UNITED STATES DEPARTMENT OF COMMERCE United States Patent and Trademark Office Address: COMMISSIONER FOR PATENTS P.O. Box 1450 Alexandria, Virginia 22313-1450 www.uspto.gov

APPLICATION NO.	FILING DATE	FIRST NAMED INVENTOR	ATTORNEY DOCKET NO.	CONFIRMATION NO.
10/556,125	11/09/2005	Edward C. Meagher	2897 US	4353
50855 Tyco Healthcar	7590 12/24/200 e Group LP	EXAMINER		
60 MIDDLETOWN AVENUE			WEEKS, GLORIA R	
NORTH HAVEN, CT 06473			ART UNIT	PAPER NUMBER
			3721	
			MAIL DATE	DELIVERY MODE
			12/24/2009	PAPER

Application No.	Applicant(s)			
Office Action Comments	10/556,125	MEAGHER, EDWARD C.			
Office Action Summary	Examiner	Art Unit			
	GLORIA R. WEEKS	3721			
The MAILING DATE of this communication app Period for Reply	pears on the cover sheet with the c	orrespondence address			
A SHORTENED STATUTORY PERIOD FOR REPL' WHICHEVER IS LONGER, FROM THE MAILING D. - Extensions of time may be available under the provisions of 37 CFR 1.1 after SIX (6) MONTHS from the mailing date of this communication. - If NO period for reply is specified above, the maximum statutory period of Failure to reply within the set or extended period for reply will, by statute Any reply received by the Office la

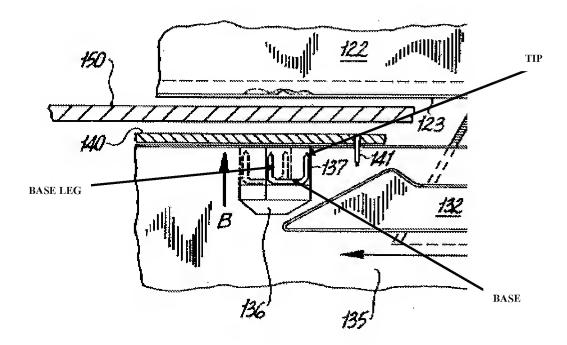
In reference to claims 1-5 and 7, McKean et al. discloses a surgical fastener system comprising: a fastener including a base leg and a support leg, the base leg being selectively deformable and including at least one traumatic tip for piercing tissue, and at least one capillary 140 having a reservoir (cellulous material) therein for retaining a liquid (column 4 lines 13-30, line 67- column 5 line 4) such that the capillary is rupturable (penetrated by tip) with the deformation of the surgical fastener; a loading unit 135; and an actuator 132.

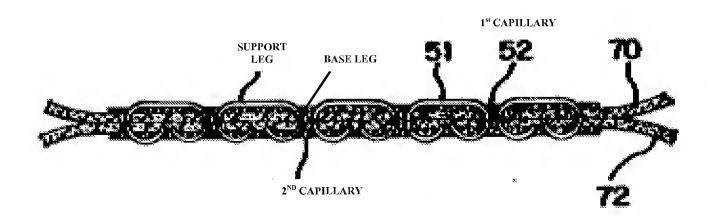
Regarding claims 6 and 8, McKean discloses a single liquid filled capillary on a base leg of a fastener. Trumbull et al. teaches a fastener that sequentially ruptures a first and second capillary 52, such that the first and second capillary 52 are on an external surface of the base leg

(figure 5 - see figure 5 diagram of Trumbull et al.). It would have been obvious to one having ordinary skill in the art at the time of the invention to modify the surgical fastener of McKean to include a second capillary as suggested by Trumbull et al. for the purpose of treating a second layer of tissue sutured by the surgical fastener.
